UNITED STATES PATENT AND TRADEMARK OFFICE

APPLICATION NO.	FILING DATE	FIRST NAMED INVENTOR	ATTORNEY DOCKET NO.	CONFIRMATION NO.
10/714,200	11/14/2003	Stefan Ihde	67185-004	2663

Office Action Summary	Application No.	Applicant(s)	
	10/714,200	IHDE, STEFAN	
	Examiner	Art Unit	
	Jonathan Werner	3732

DETAILED ACTION

Figure 1 – Streel (US 4,344,757)

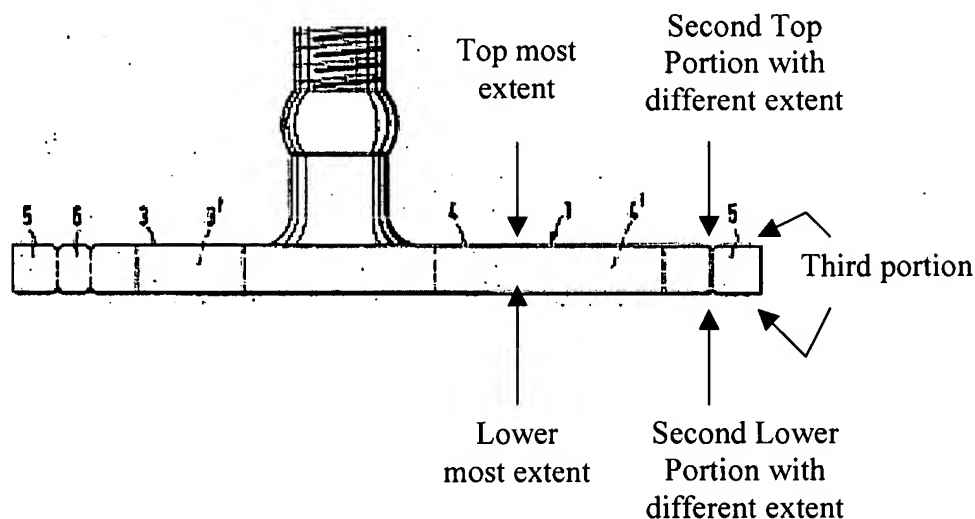
4. Claims 23-30, 35, 39 and 41-42 are rejected, as understood, under 35 U.S.C. 102(b) as being anticipated by Streel (US 4,344,757). As to claims 23 and 42, Streel discloses a dental implant comprising a post (2) having a first end a second end; said first end having a mount for a device to be implanted (Figure 3 and 5); said second end being attached to a base (Figures 1 and 2); said base being substantially orthogonal to said post in at least two non-parallel directions (Figures 1 and 2); said base having a bottom surface and said bottom surface having a lower most extent (Figure 1 below); and said base having a top surface having a first portion having a topmost extent (Figure 1 below); and at least one of said top surface or said bottom surface having a second portion having a second extent different from said topmost extent or said lower most extent (Figure 1 below). Examiner notes that no description or support of said portions are given in the applicant's specification, and hence are interpreted as previously described. As to claim 24, at least one of said top surface or said bottom surface of said base has a third portion, said third portion being equivalent to said top most extent and said third portion being separated from said first portion by said second portion (Figure 1 below). As to claim 25, Figures 1 and 2 show, for example, a first group of portions (5,6,7) having a topmost extent, and a second group of portions (8) having an extent in a direction parallel to the post that is less than the extent of the first portions. As to claim 26, the first portions (5,6,7) and the second portions (8) alternate

periodically as seen in Figures 1 and 2. As to claim 27, the first portions and the second portions are alternating corrugations (8). As to claims 28 and 29, at least one of said portions has a sharp edge (Figure 1) and at least one of said portions constitutes a ridge (Figure 1). As to claim 30, at least one of said portions constitutes a trough (8). As to claim 35, the base has an outer perimeter and said outer perimeter includes at least three substantially straight edges (Figure 2). As to claim 39, Figures 1 and 2 show the second portion is at a marginal zone of said base, said marginal zone being substantially along a portion of a periphery of said base. As to claim 41, the marginal zone comprises reentrant angles (Figure 1).
